APPLICATION NO.	FILING DATE	FIRST NAMED INVENTOR	ATTORNEY DOCKET NO.	CONFIRMATION NO.
10/046,285	01/16/2002	Jae Sung Kim	RPL-0025	2364

SUPPLEMENTAL
Office Action Summary

SUPPLEMENTAL DETAILED ACTION

Fig. 4

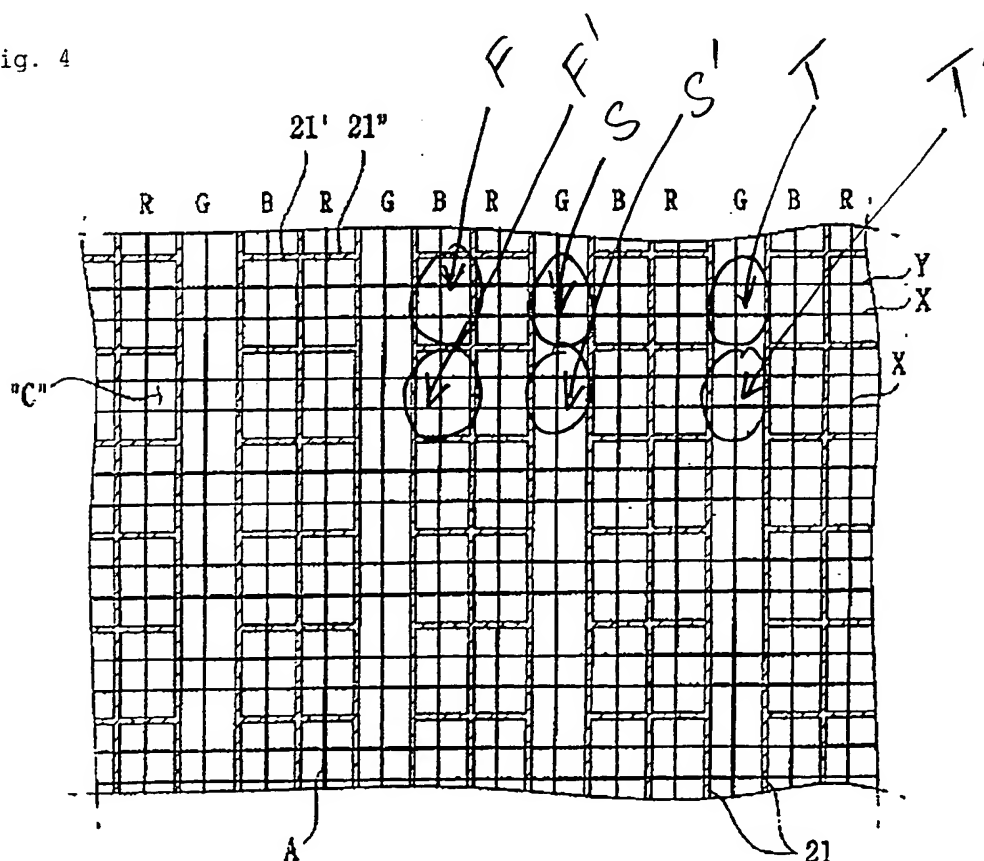
Regarding claims 9-11, the admitted prior art shown in figure 4 clearly discloses plasma display device comprising:

three sets of discharge cells are separated by barriers;

each cell of first blue discharge cells (F, marked by examiner) is separated from another adjacent cell of the first blue discharge cells (F', marked by examiner);

each cell of second set of discharge cells (S, marked by examiner) is separated from another adjacent cell of the second discharge cells (S', marked by examiner); and

each cell of third set of discharge cells (T, marked by examiner) is separated from another adjacent cell of the first blue discharge cell (T', marked by examiner).
